<b>Product / Process Change Notification (PCN)</b>	
<input checked="" type="checkbox"/> Major Change <input type="checkbox"/> Minor Change	
<b>PCN Number:</b> PCN_ConMPC3_20241204  <b>Affected Series:</b> WR-MPC3  <b>Affected Order Codes:</b> see table below  <b>PCN Date:</b> 2024-09-04 (YYYY-MM-DD) <b>Effective Date:</b> 2024-12-04 (YYYY-MM-DD)	<b>Change Category:</b> <input type="checkbox"/> Equipment/Location <input type="checkbox"/> General Data <input type="checkbox"/> Material <input type="checkbox"/> Process <input type="checkbox"/> Product Design <input checked="" type="checkbox"/> Shipping / Packaging <input type="checkbox"/> Supplier <input type="checkbox"/> Software
<b>Contact:</b> Product Management <b>Phone:</b> +49 (0) 7942 - 945 5001 <b>Fax:</b> +49 (0) 7942 - 945 5179 <b>E-Mail:</b> pcn.eican@we-online.com	<b>Datasheet Change:</b> <input checked="" type="checkbox"/> Yes <input type="checkbox"/> No  <b>Attachment:</b> <input type="checkbox"/> Yes <input checked="" type="checkbox"/> No

<b>Description of Change:</b>  <p>Due to packaging optimizations, Würth Elektronik eiSos will change the Tube packaging by a Tray packaging. There will be no change in form, fit, funct

1. 6620xx2112y

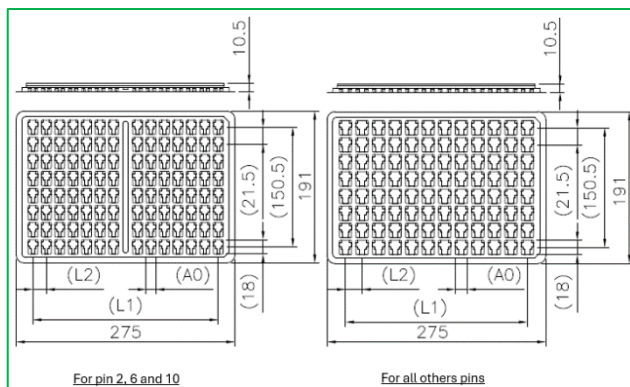
a. Packaging change

2. 6620xx23592y

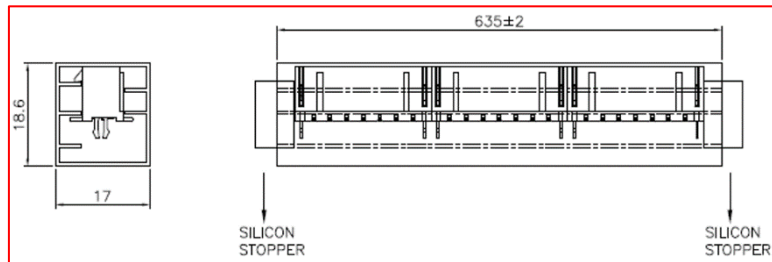
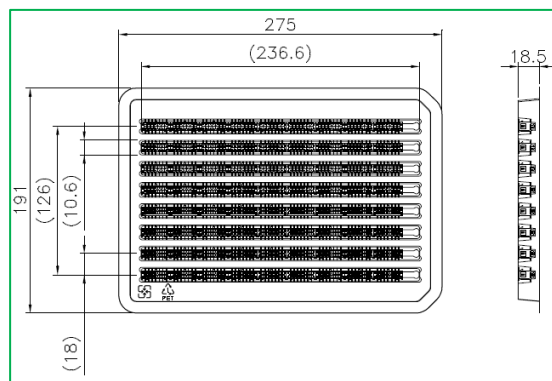
a. Packaging change

3. 6620xx1102y

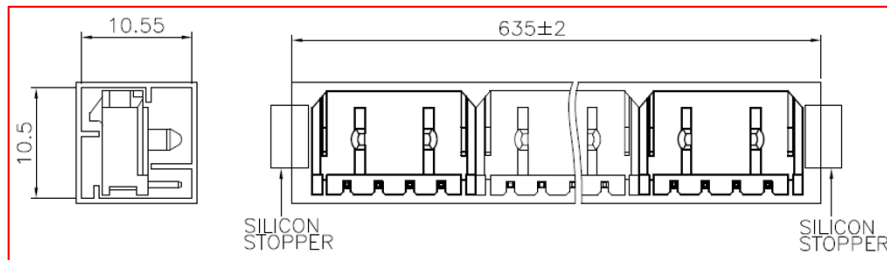
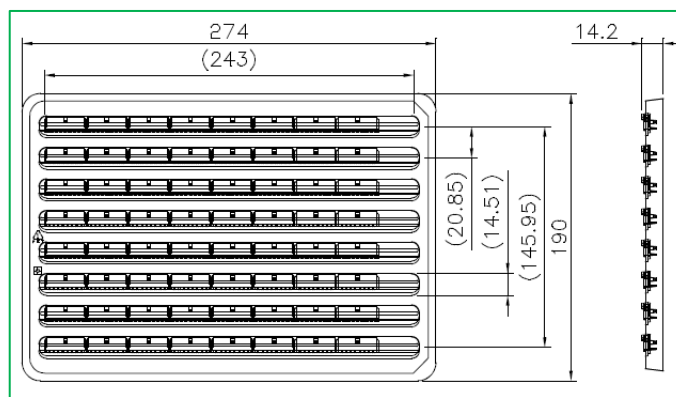
a. Packaging change

4. 6620xx1112y

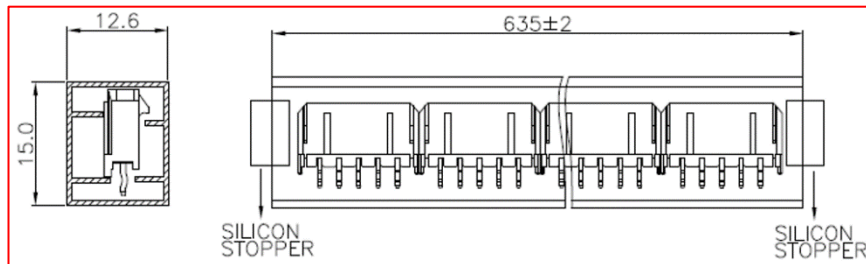
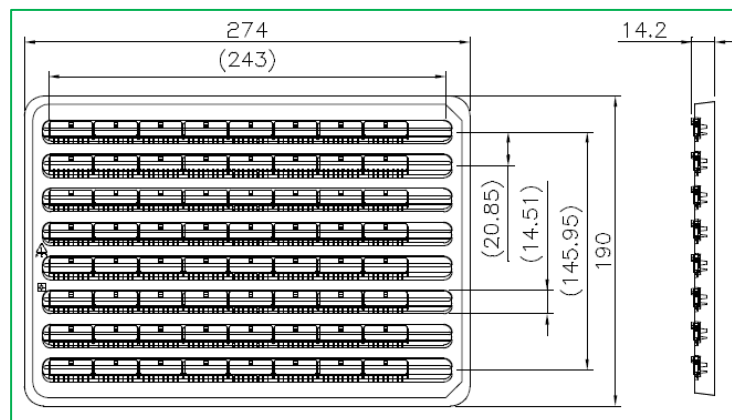
a. Packaging change

5. 6620xx23082y

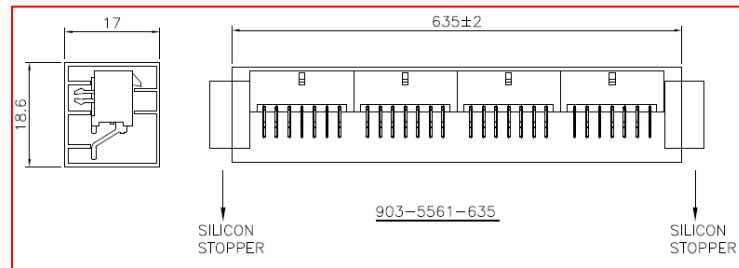
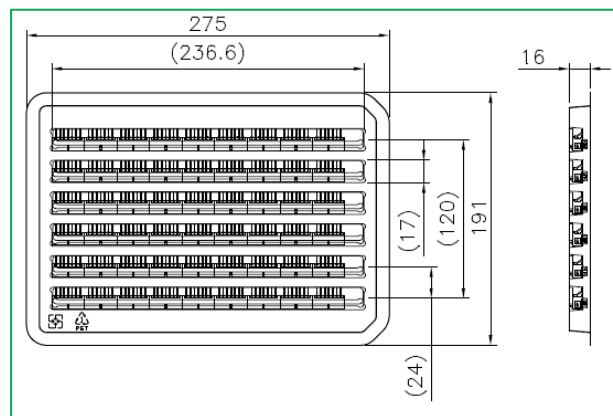
a. Packaging change

6. 6620xx23602y

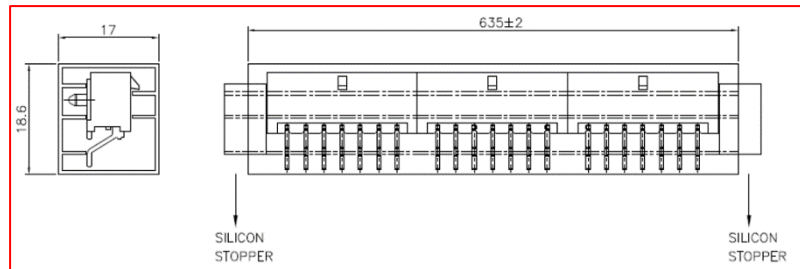
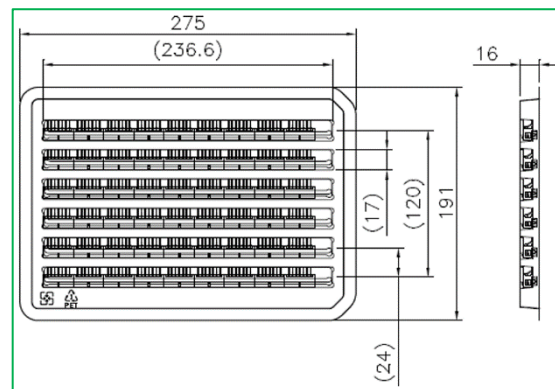
a. Packaging change

7. 6620xx2102y

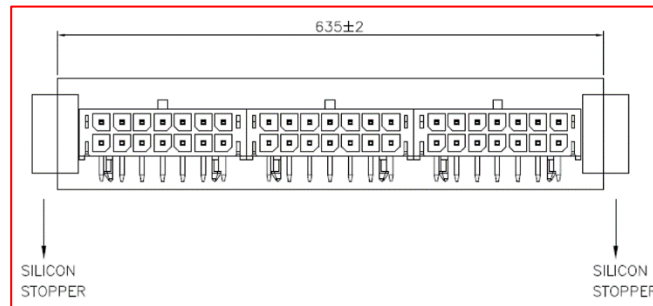
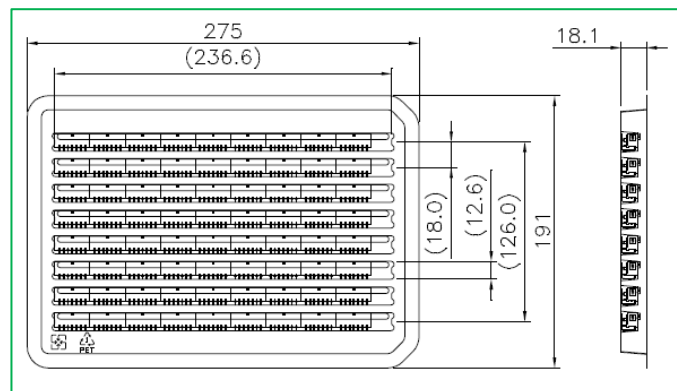
a. Packaging change
